DOCUMENT NO: OP-1903.004

TITLE: ADMIN. & MAINTENANCE OF THE
EMERGENCY PLAN & IMPLEMENTING
PROCEDURES

CHANGE NO: 023-00-0

ENTERGY OPERATIONS INCORPORATED ARKANSAS NUCLEAR ONE

ATTACHMENT 1
(P-14145 Complete Attachment)
EMERGENCY PLAN AND
IMPLEMENTING PROCEDURES REVIEW

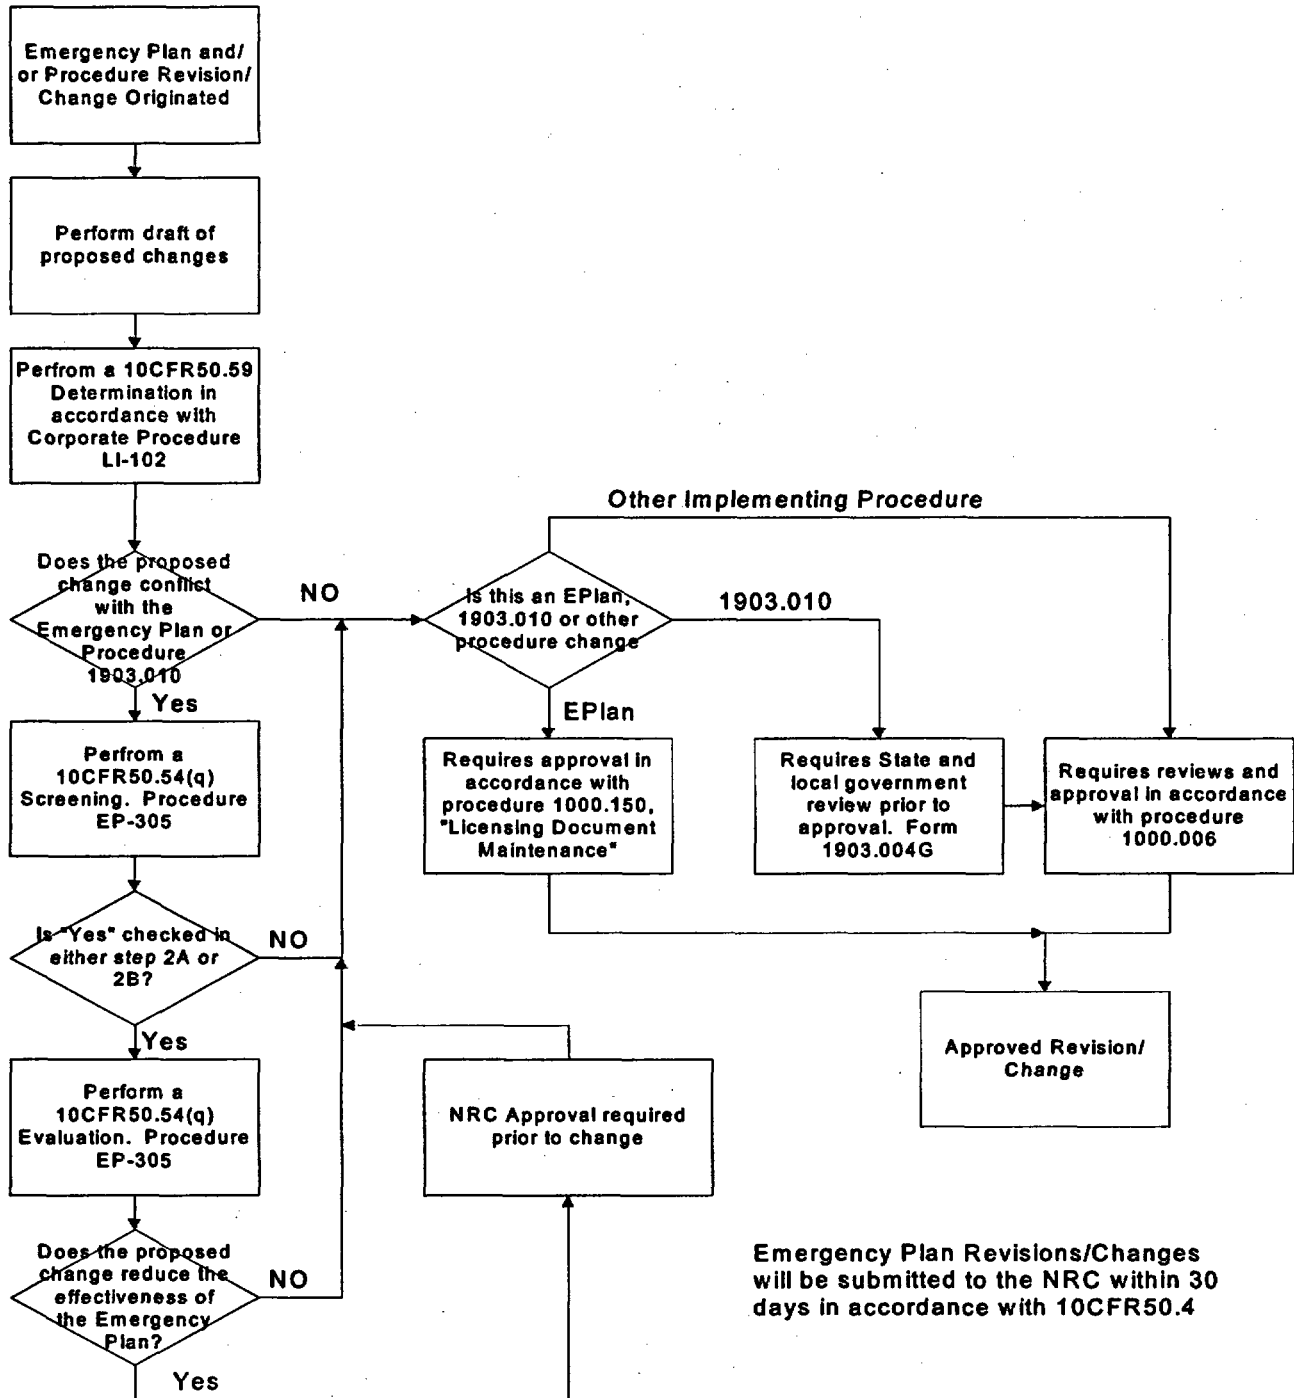
Step 14.2.7 Page 21	Added Form 1903.004K to document oversight performance.		
Attachment 1 Page 22	Corrected spelling of Perform and changed Form 1903.004F to 1903.004G.		
Attachment 3 Page 24	A&N changed to Alert Notification System (ANS) for Procedure Consistency.		
Attachment 4 Page 25	New Attachment to provide instructions for monitoring the ANS system.		
Form 1903.004A Page 26	Revised Request NO. to CR/WT NO. and added "entered by" line.		
Form 1903.004D Page 29	Changed Manager, RP & Chemistry to Superintendent, RP & Chemistry to reflect current ANO management organization		
Form 1903.004K Page 33	New Form 1903.004K to document oversight performance.		
FORM TITLE: DESCRIPTION OF CHANGE		FORM NO. 1000.006C	CHANGE NO. 050-00-0
